Value Engineering

Final Report

Intake Diversion Dam Fish Protection and Passage Concept Design, Lower Yellowstone Project

July 29, 2002

Figure 14. Fish Screen in Front of Screen

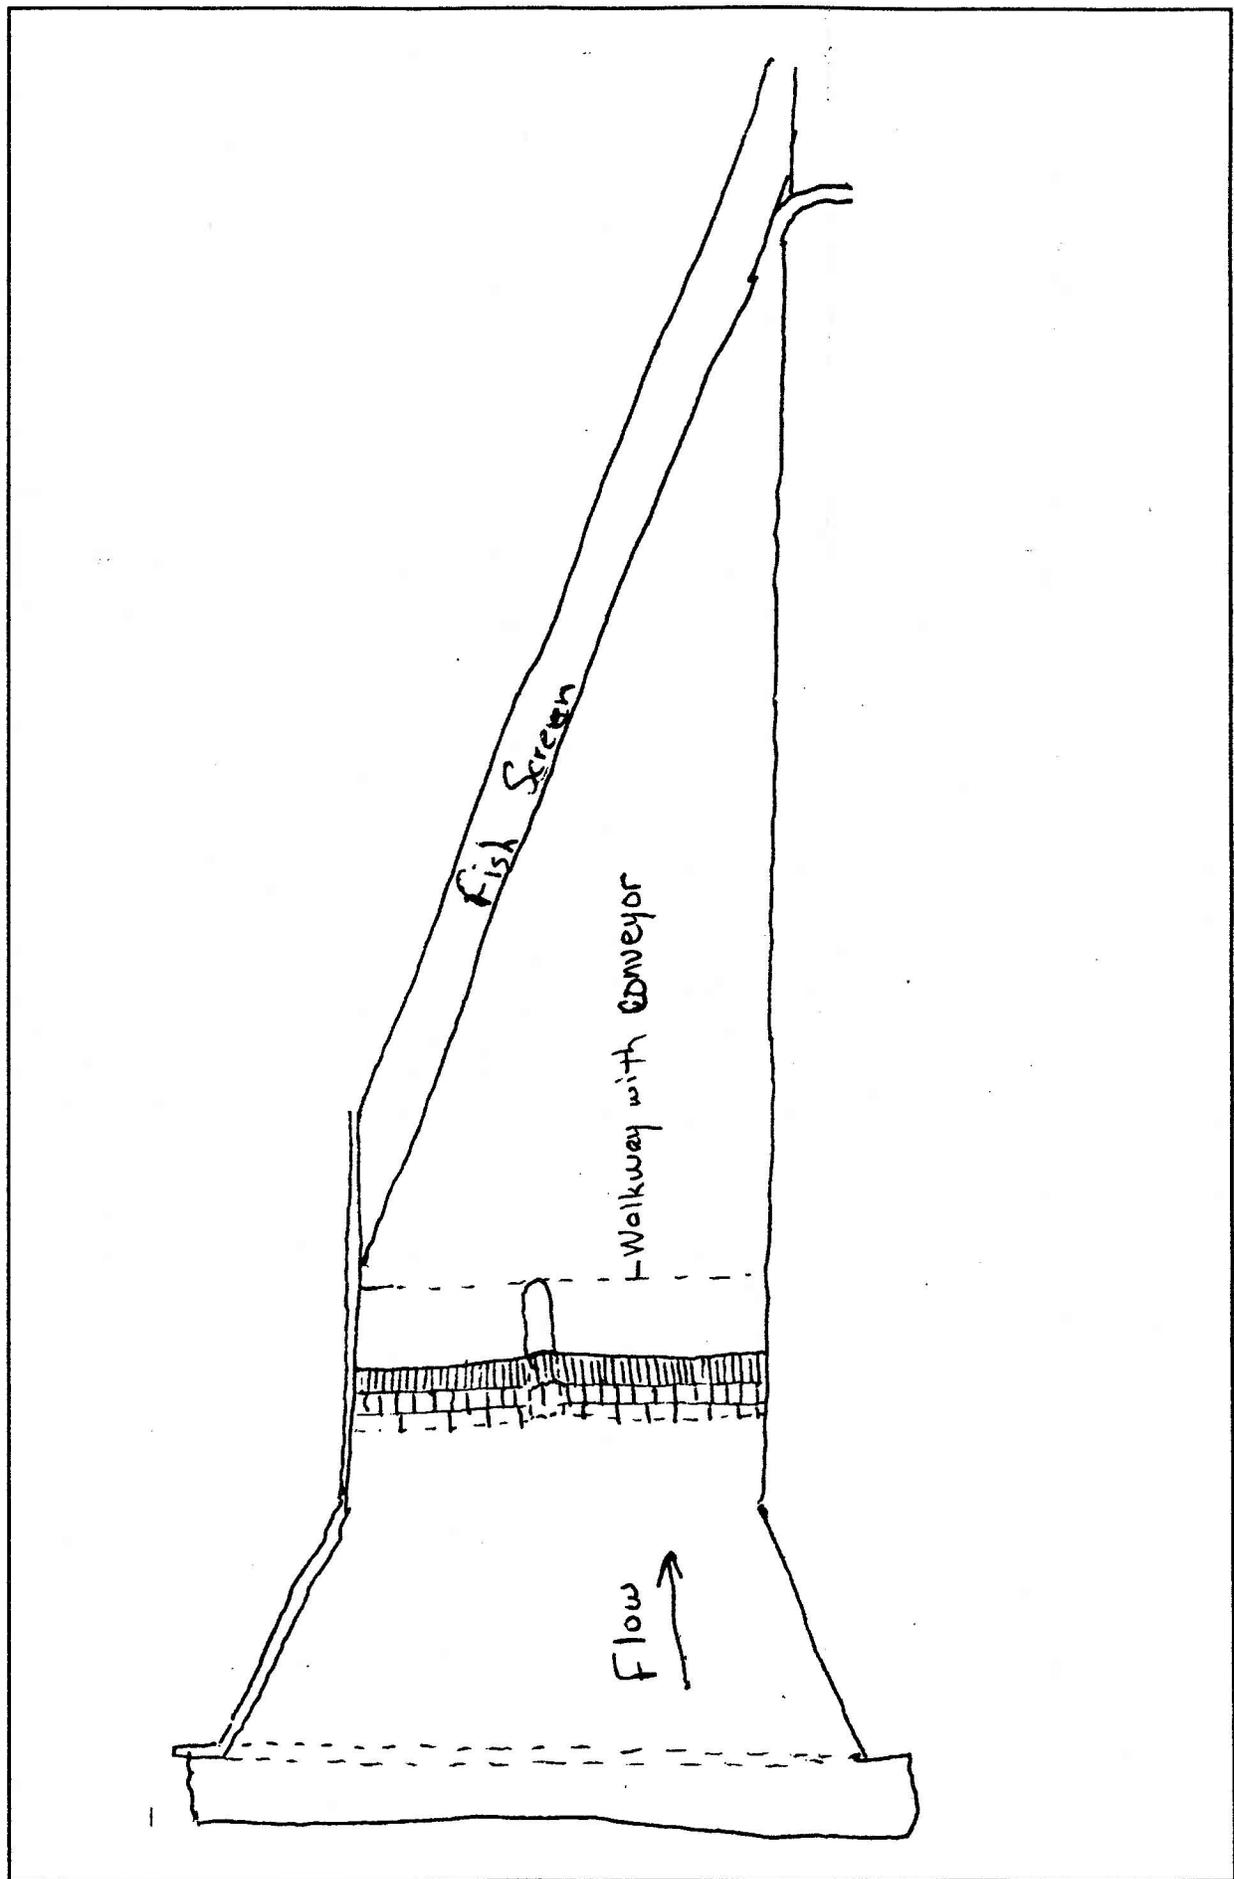
Proposal No. 4. Install Trashrack in Front of the Fish Screen.

- **Proposal Description:** This proposal would install a trashrack upstream of the fish screen to collect and remove large debris that is entrained through the primary intake. The rack would consist of a structure with a middle pier with variable bar spacing to provide the greatest opportunity for fish passage. The portion of the rack in the upper half of the water profile would consist of bars set vertically with a 4-inch spacing, the mid-section of the water profile would have a spacing of about twelve inches and the lower 3-foot portion would have a spacing of approximately 24 to 48 inches. A hydraulic trash rake and conveyor would be included to provide a mechanical means of removing the debris for collection and removal.

Figure 15. Plan of Wall and Slab Eliminated

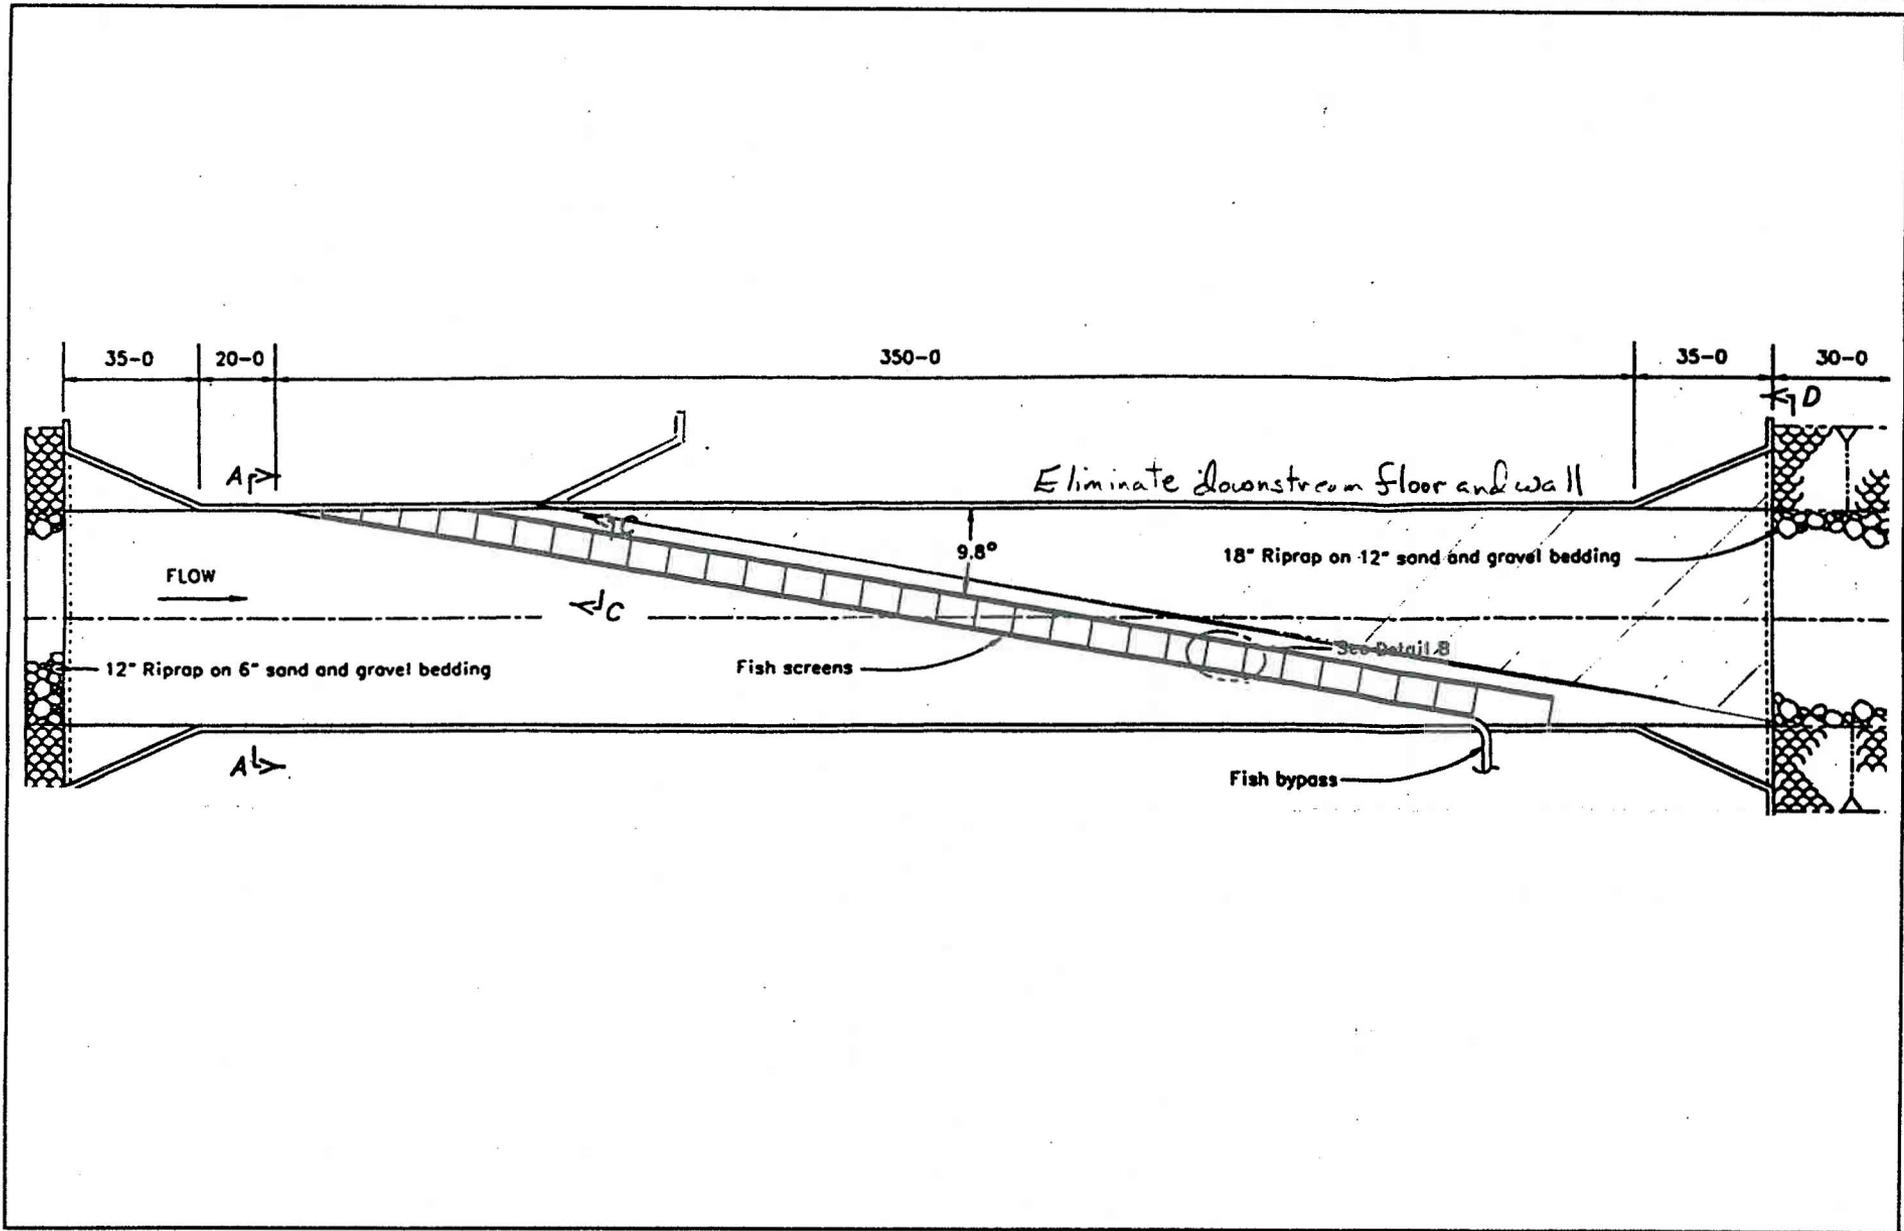
Proposal No. 5. Reduce Concrete in the Fish Screen Structure

- Proposal Description: This proposal would eliminate a section of concrete floor and wall downstream of the fish screens. The left side of the transition at the lower end of the structure would be relocated to just downstream from the upper end of the fish screen. The concrete floor of the canal would be reduced to only that needed for a foundation for the screen structure.
- Critical Items to Consider: Analysis may be performed to determine if bank armor and canal floor riprap are needed to control scour on the downstream side of fish screen.
- Ways to Implement: None noted.
- Changes from the Baseline Concept: This proposal would reduce the area of concrete.

Figure 16. Wall Section

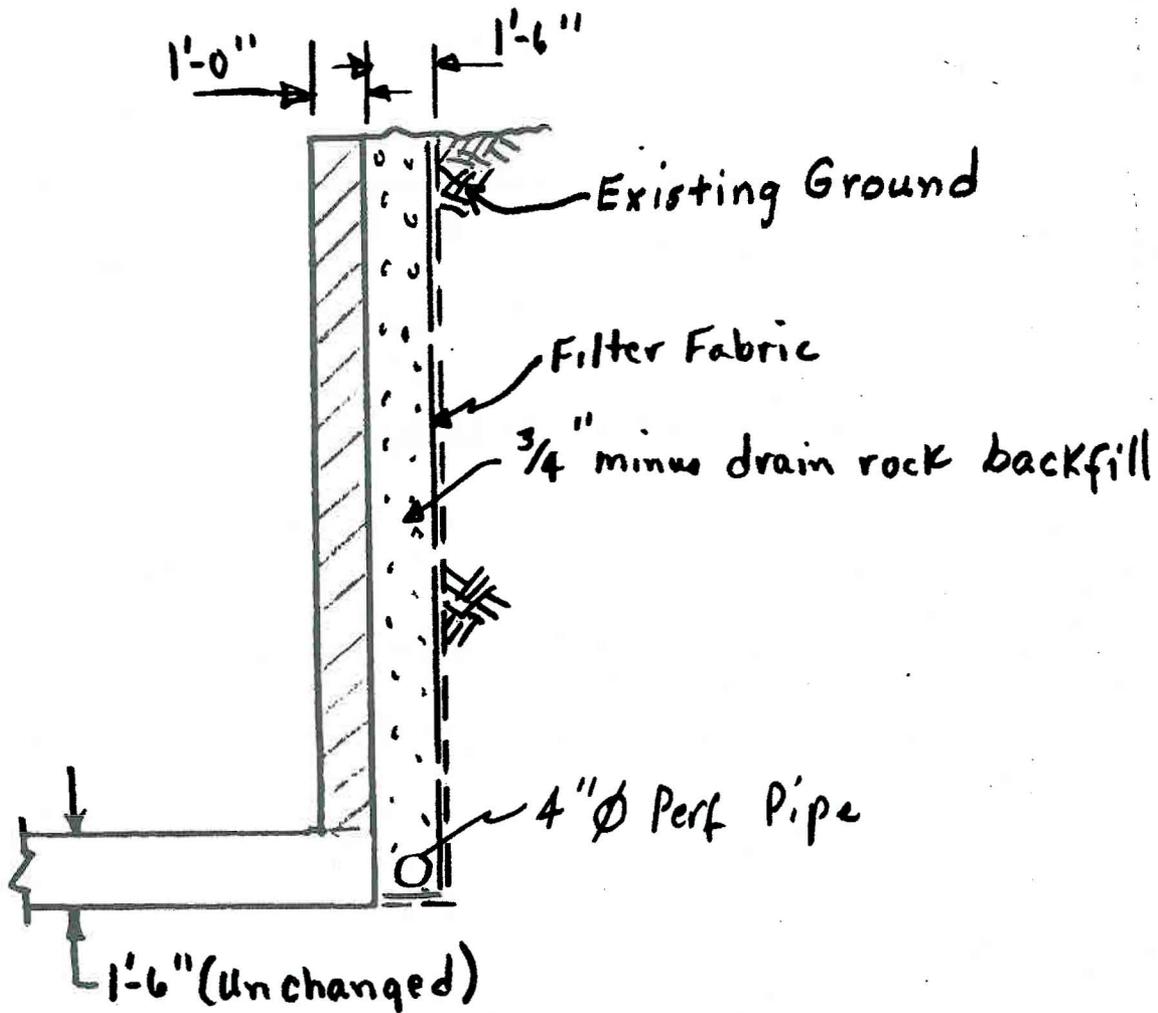
Proposal No. 7. Reduce Screen Structure Wall Thickness.

- **Proposal Description:** This proposal would reduce the thickness of concrete walls from 1 ½-foot to 1-foot. Freeze-thaw problems would be avoided by adding a 1 ½-foot-thick section of drain rock backed by a filter fabric. Water collected between the concrete wall and the filter fabric would drain through a 4-inch perforated pipe at the foot of the wall.

Thickness changed from 1'-6" Base Proposal
